Intel[®] Mobile Celeron[™] Processor at 466 MHz, 433 MHz, 400 MHz, 366 MHz, 333 MHz, 300 MHz, and 266 MHz Specification Update

Release Date: April 2000

Order Number: 244444-014

The Intel[®] Mobile Celeron[™] processor at 466 MHz, 433 MHz, 400 MHz, 366 MHz, 333 MHz, 300 MHz, and 266 MHz may contain design defects or errors known as errata which may cause the product to deviate from published specifications. Current characterized errata are documented in this Specification Update.

Figure 2. Workaround Flowchart: SMBALERT#-Driven System

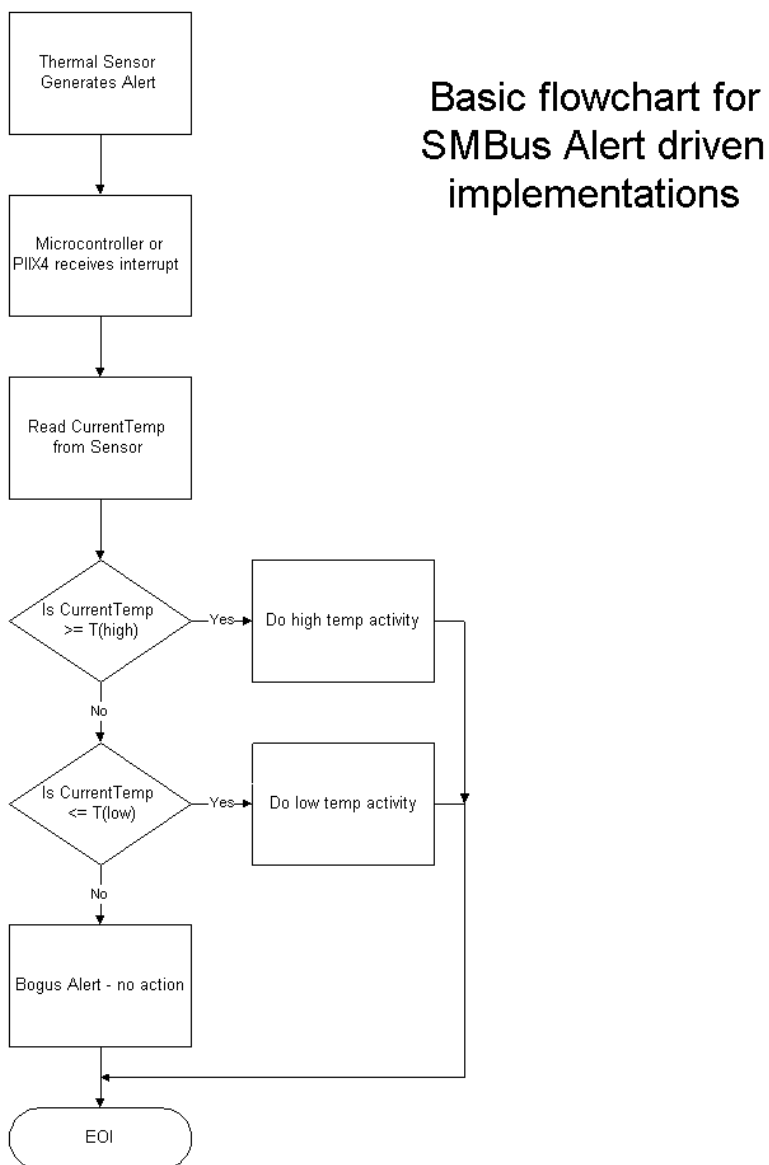
H29. Thermal Sensor May Assert SMBALERT# Incorrectly

Problem: The Intel Celeron Processor Mobile Module has a thermal sensor that monitors the processor core's temperature. Please note that desktop systems could have a similar thermal device. The thermal sensor asserts SMBALERT# if the processor temperature exceeds the temperature limits set in the Alarm Threshold Registers (T_{HIGH} , T_{LOW}). It also sets the corresponding Status Register bits to identify the cause of the interrupt. Figure 1 gives one example of the how the SMBALERT# signal could be used in a system.

Workaround: Three different (mutually exclusive) workarounds are possible:

1. Before servicing an interrupt from the thermal sensor, read and compare the processor thermal reading with the threshold limits (T_{HIGH} or T_{LOW}). Figures 2 and 3 provide basic flowcharts for the implementation of this workaround in an interrupt driven system.
2. If the firmware implemented polls the Status Register only, then before taking any action, re-read the temperature register and do a comparison with the alarm threshold limits (T_{HIGH} or T_{LOW}) to determine if the value is actually still within the temperature window.
3. Use a temperature polling scheme to monitor the processor temperature.

Figure 5.4. Surface-Mount BGA1 Package—Bottom View

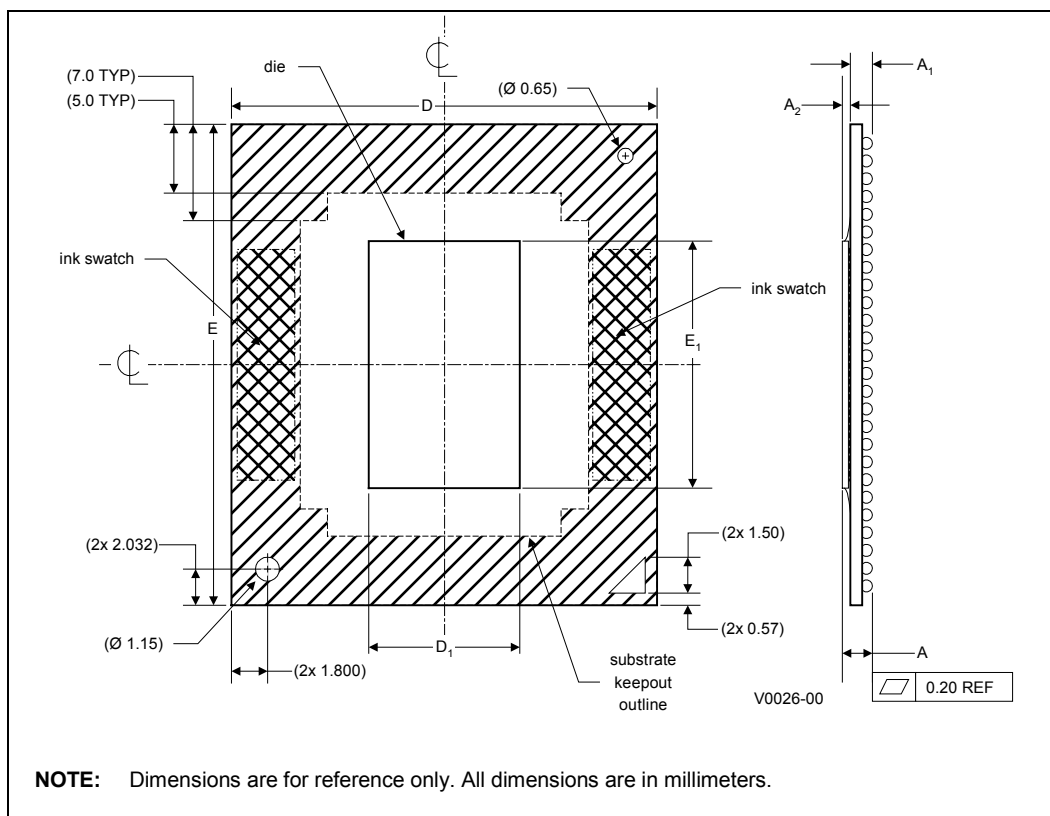
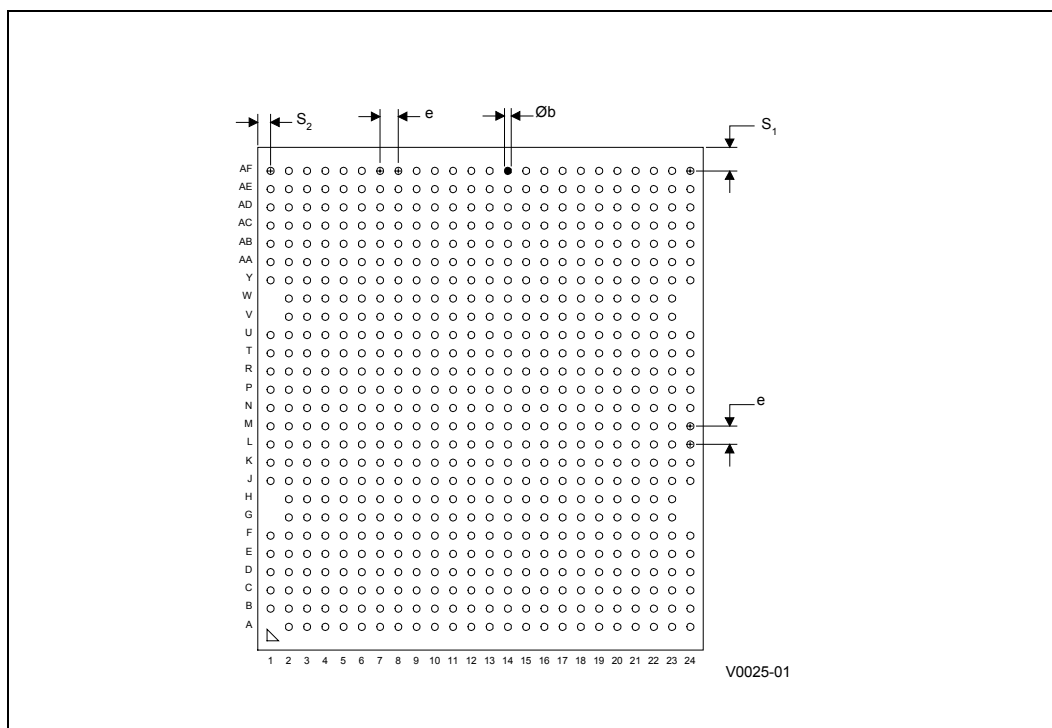
The following table and figures show the updated mechanical specifications for the BGA1 package, listed as Table 5.2, Figure 5.3 and 5.4, respectively, in the *Intel® Mobile Celeron™ Processor in BGA Package at 333 MHz, 300 MHz and 266 MHz* datasheet.

1. The number shown here is different from that in the 244444-004 version of this specification update. The maximum reference number is used.

Figure 3.3 Generic Clock Waveform

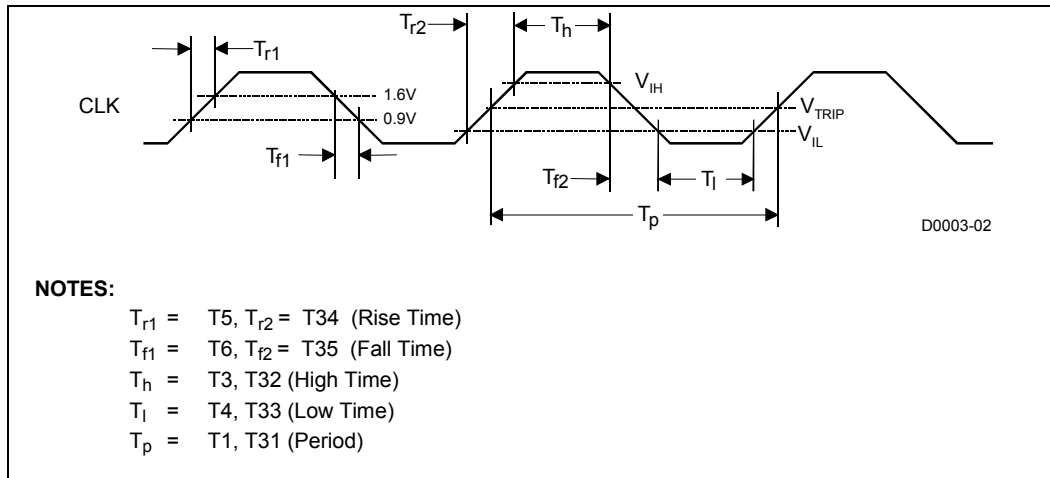
H11. Generic Clock Waveform Figure

Figure 3.3 in the *Intel® Mobile Celeron™ Processor in μ PGA1 and BGA1 Packages at 366 MHz, 333 MHz, 300 MHz, and 266 MHz* datasheet (Order Number 245112-003) has been updated. The following figure is to replace the one in the above document.
